Plan Commission

Agenda

Monday, November 30, 2015	7:00 PM	De Pere City Hall Council Chambers
----------------------------------	----------------	---

SUBJECT: Review and Recommendation on the Site Plan Application for St. Norbert College Sports Center Facility (601 Third Street).
Applicant: St. Norbert College

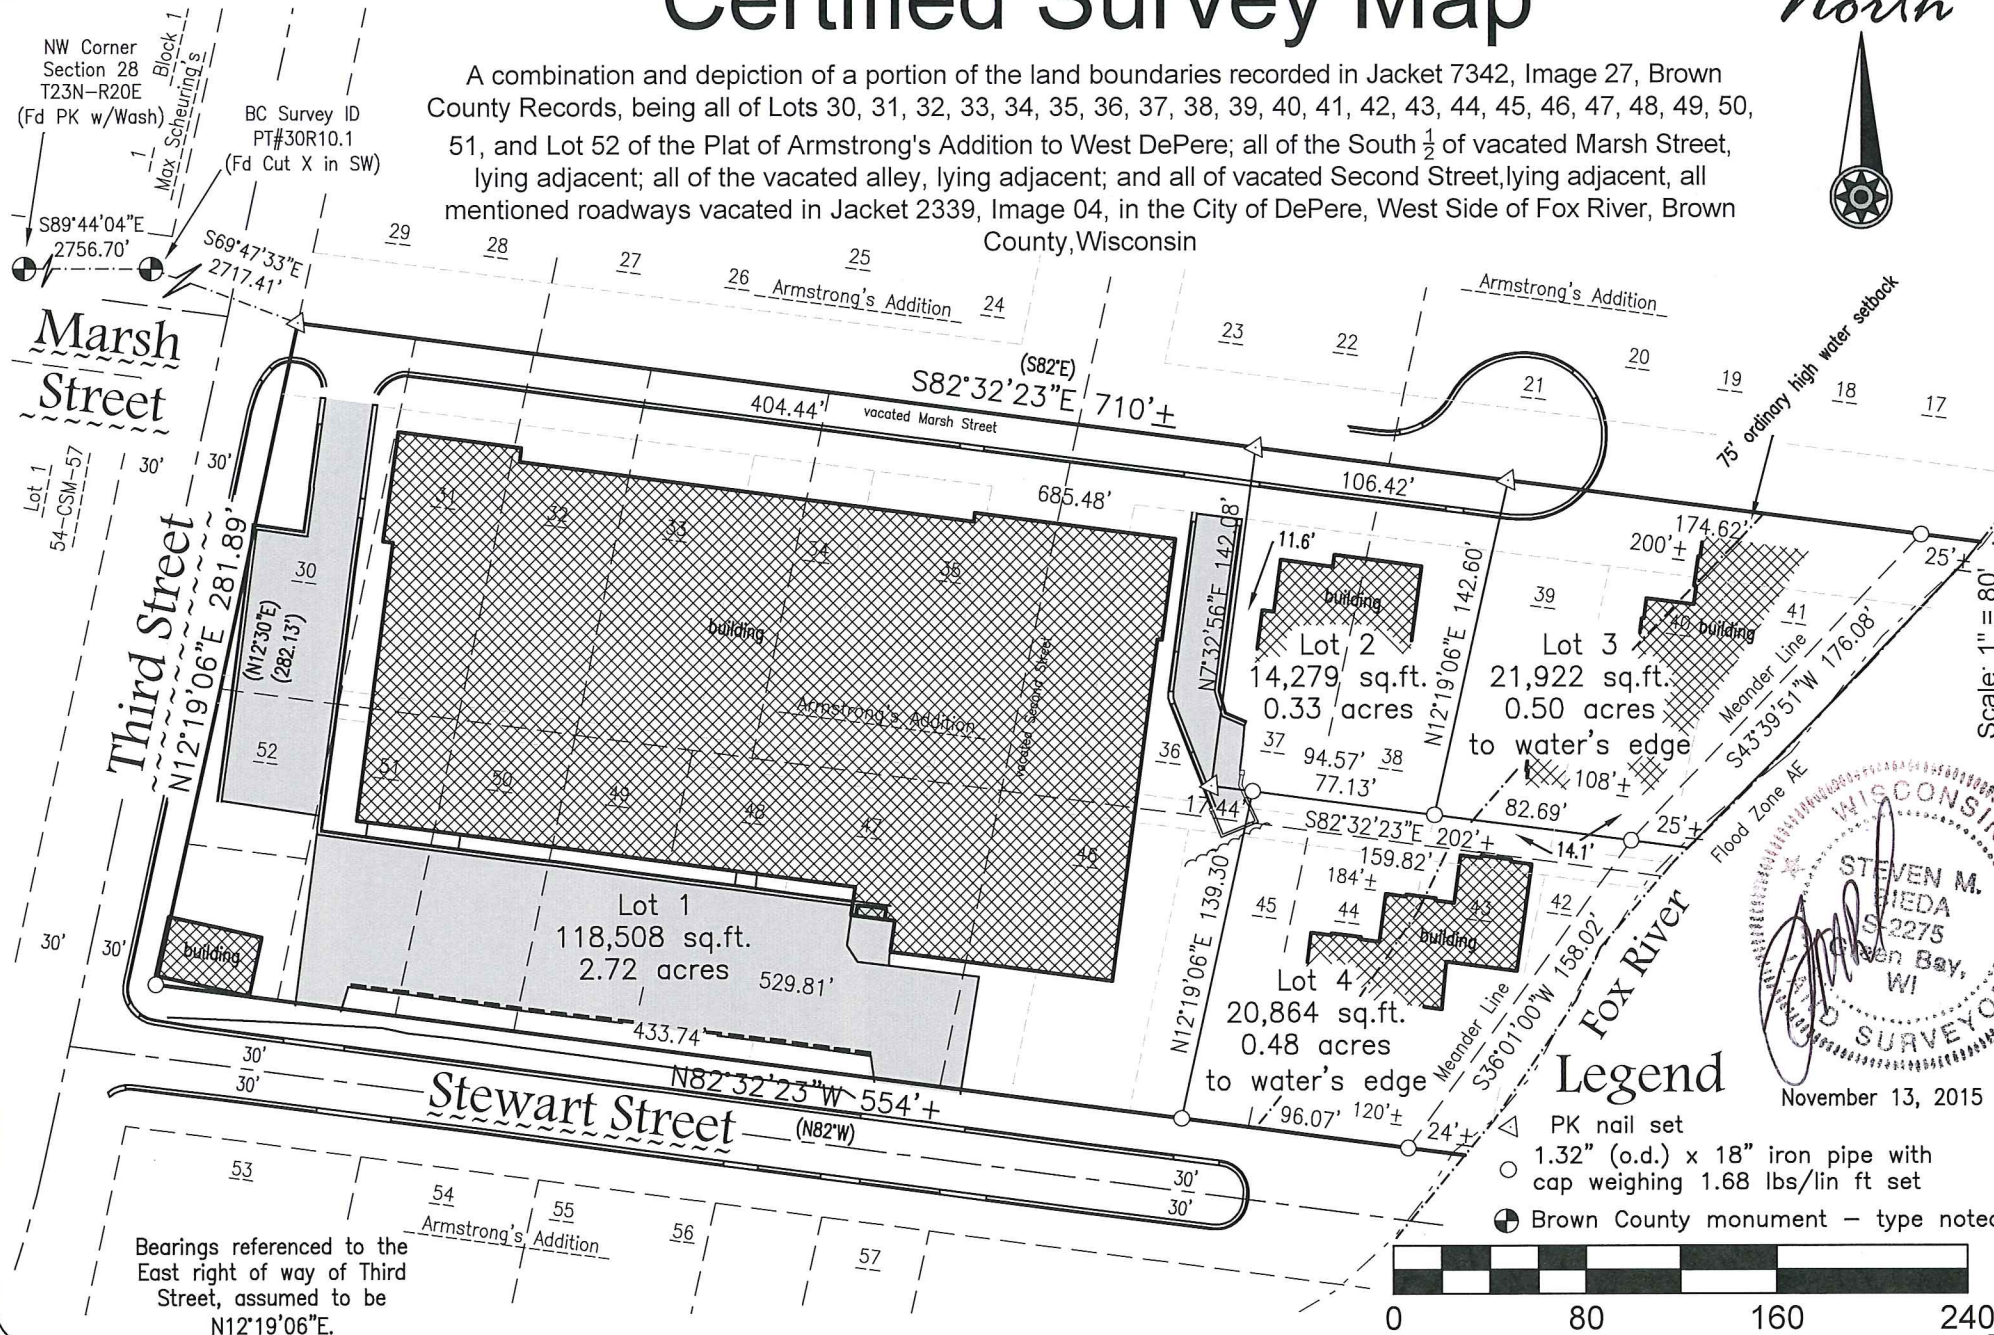
1. Provide an access easement for lots 2 and 3
2. Identify and show all current easements on the CSM
3. CSM must meet the requirements specified by Brown County Planning
4. Certificate for the City of De Pere should be Shana Ledvina, City Clerk

SITE
PLAN

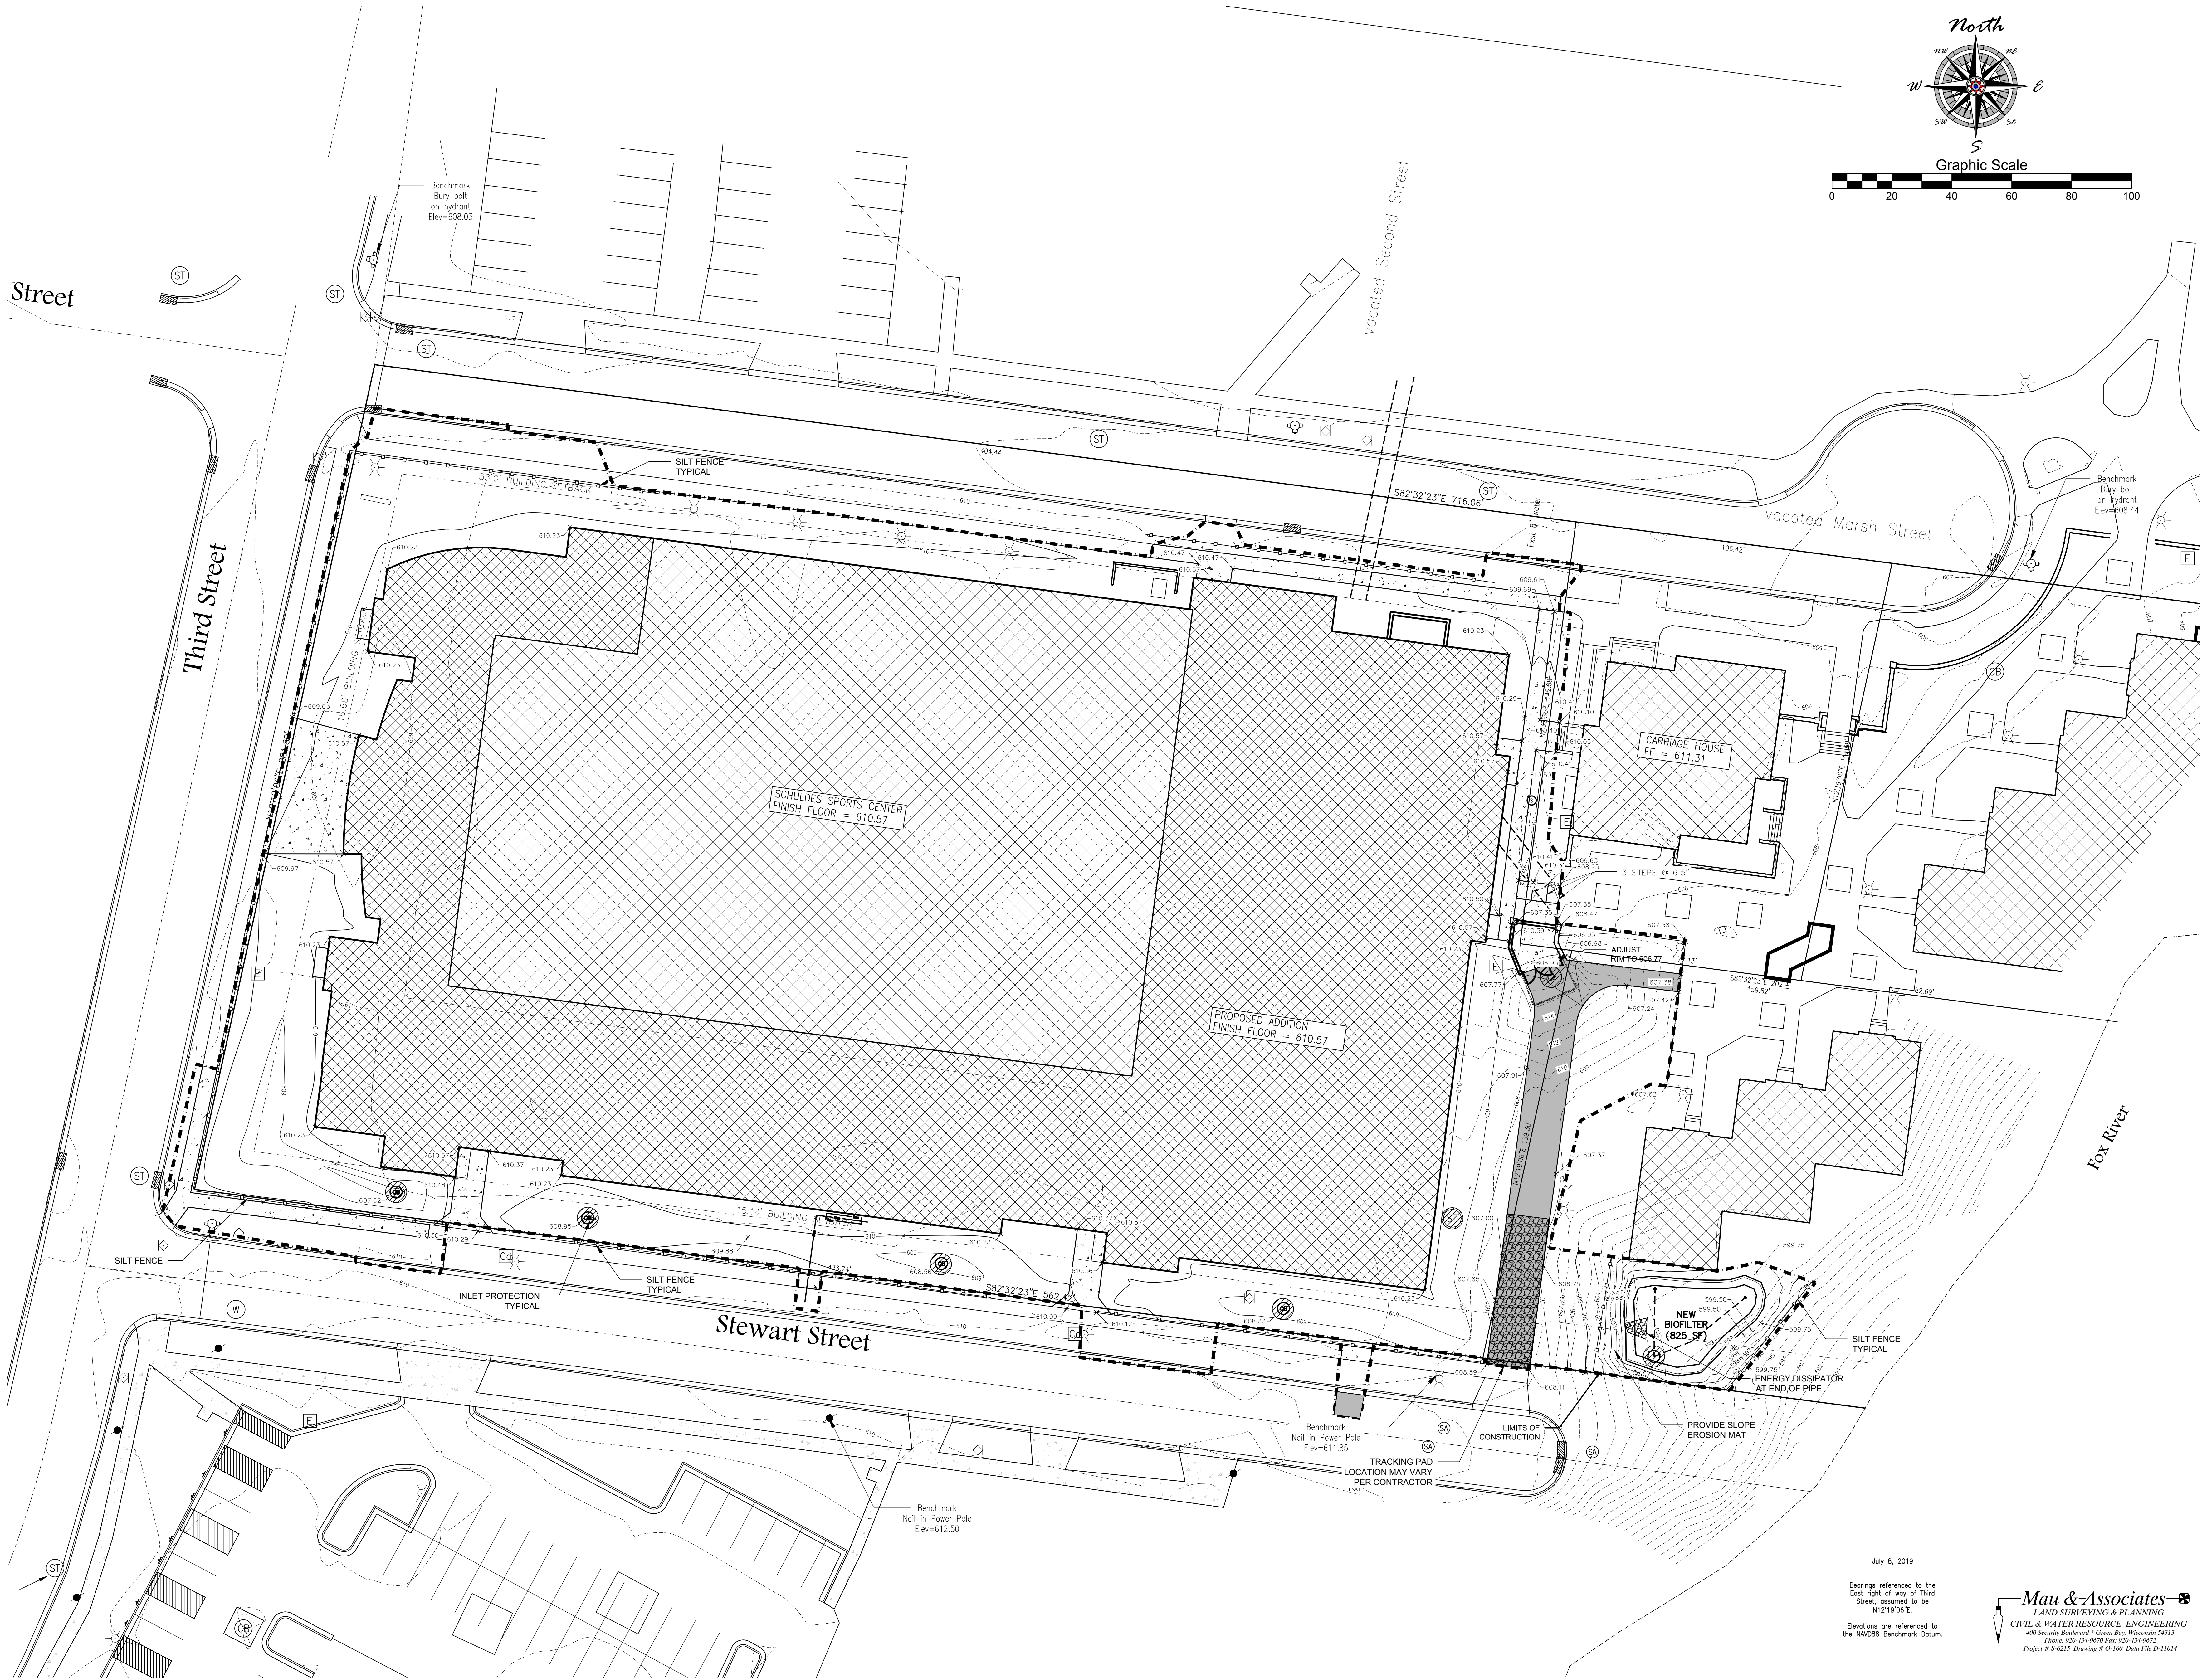
1. A new 8" sanitary sewer lateral is shown connecting to the City's 12" concrete sanitary sewer. The connection is aligned against the direction of flow. Revise the connection to the City sewer at an angle of 90 degree or less with the upstream sewer. Reconstruct/construct the bench to channel the flow. It may be more cost effective to install a new manhole than to reconstruct the bench in the existing manhole.

4. The plan shows a new 8" water service connecting to a private water main on vacated Stewart Street. The connection is shared with a second building. Consider a separate connection to the Third Street water main.

5. Notify the Water Department one month in advance of the meter installation so the meter can be ordered.
6. The water main on Stewart Street is 4" Cast Iron, not 8" as shown on the plan.

8. Note on the plan that, "Abandon water taps to the City water main under the observation of City personnel".
9. The new hydrant shown on Stewart Street needs to be constructed in the City right of way, owned by the City, and maintained by the City. The location of the hydrant needs to be discussed further.

16. Rerouting of fiber optic line within the street right of way will require a street excavation permit.
17. Show easements for vacated Marsh Street and the sanitary sewer along the east side of the site on the plan.
